**FINAL DRAINAGE REPORT FOR  
~~TRACT IN NE4NW4 SEC 18-14-65~~  
2601 EAST PLATTE AVENUE  
COLORADO SPRINGS, COLORADO 80916**

JULY, 2021

TERRA NOVA ENGINEERING, INC.  
721 S. 23RD STREET  
Colorado Springs, CO 80904  
(719) 635-6422

PCD Filing No.:  
MS-21-008

FULL SPECTRUM EXTENDED DETENTION BASIN DETAIL

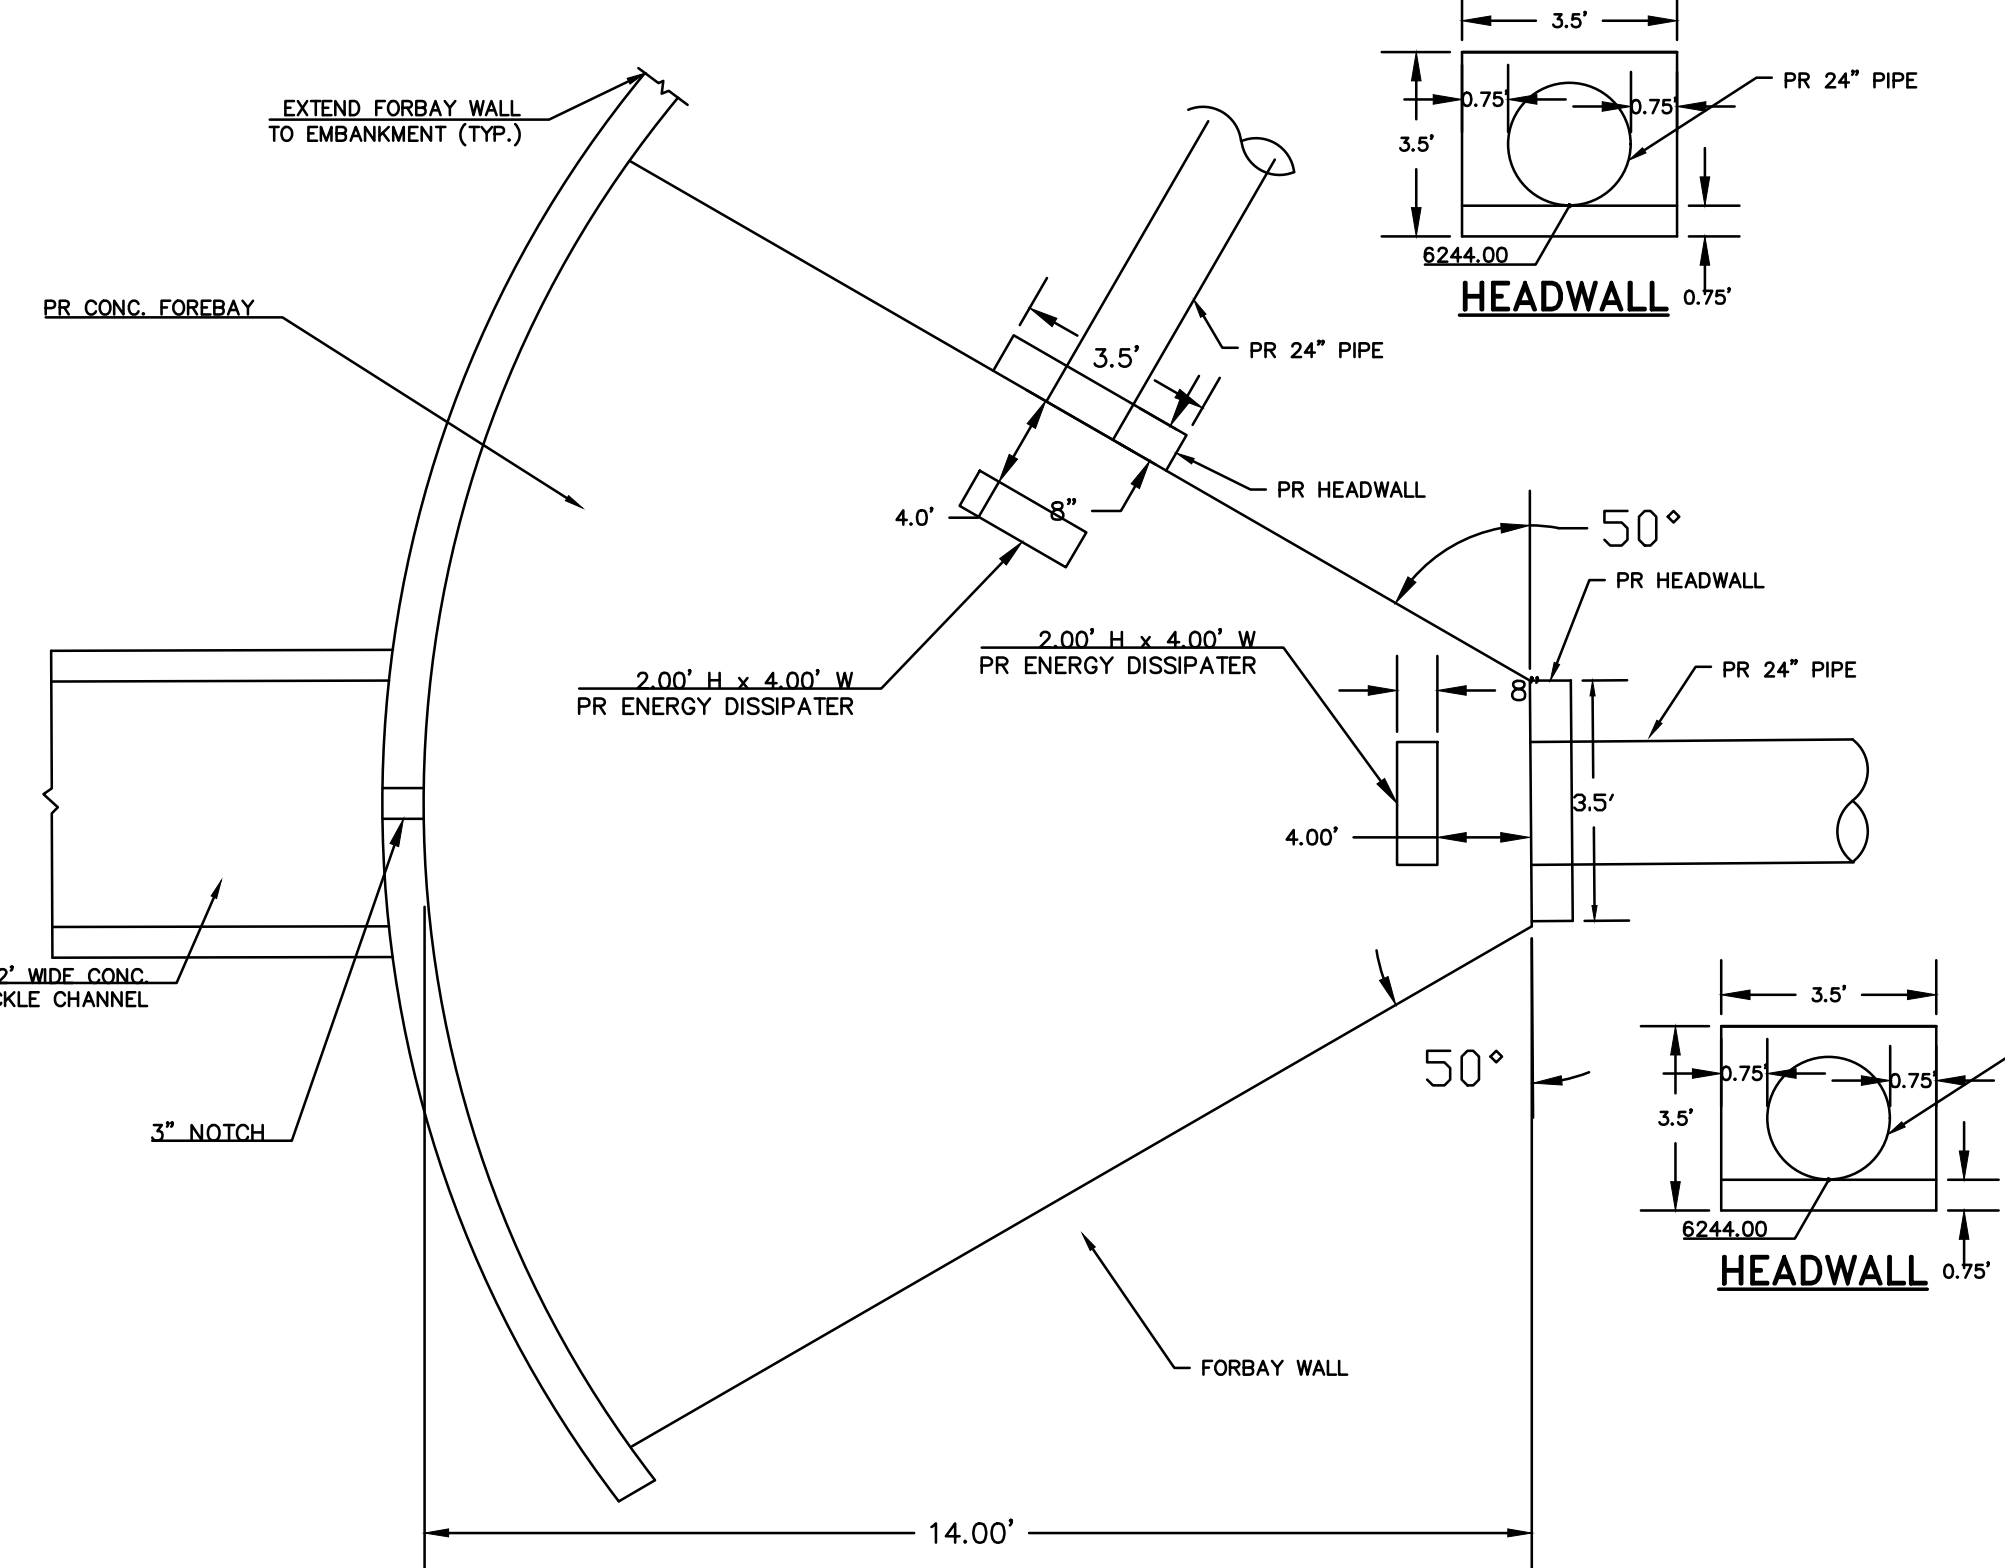
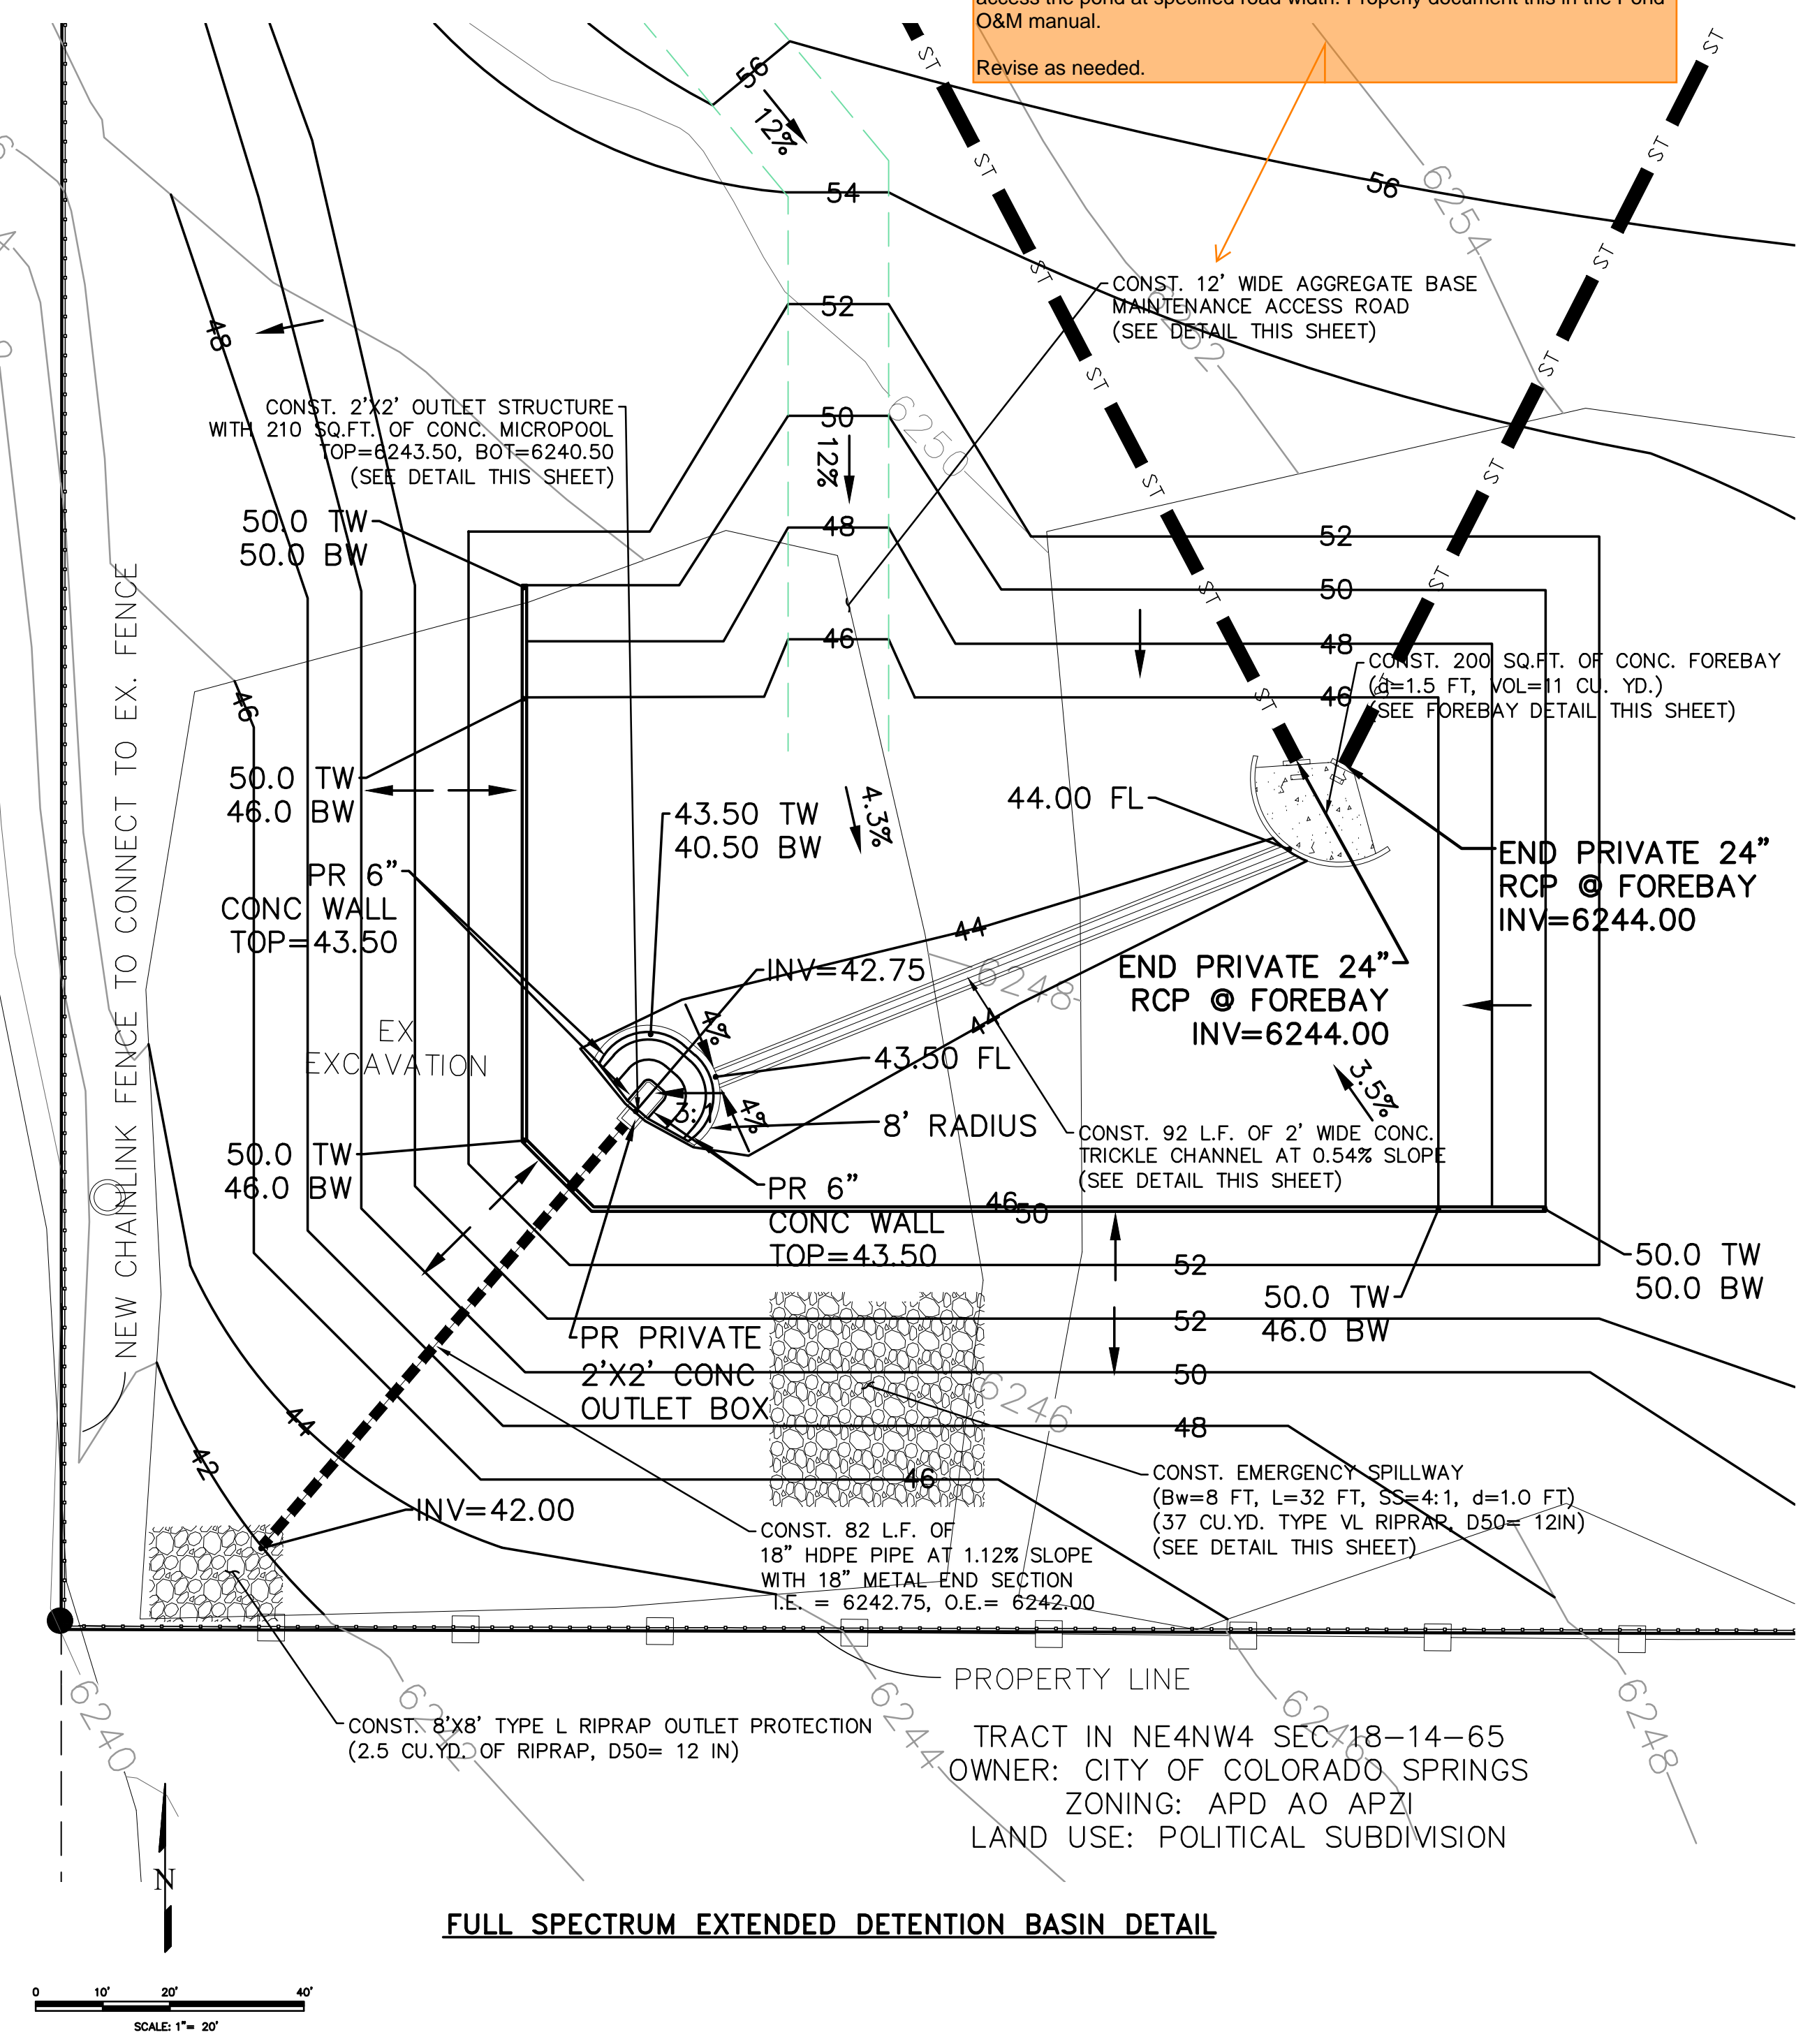
Include forebay and micropool sizing and well screen calcs with this drainage report. MHFD has the UD-BMP spreadsheet that does these calcs for you.
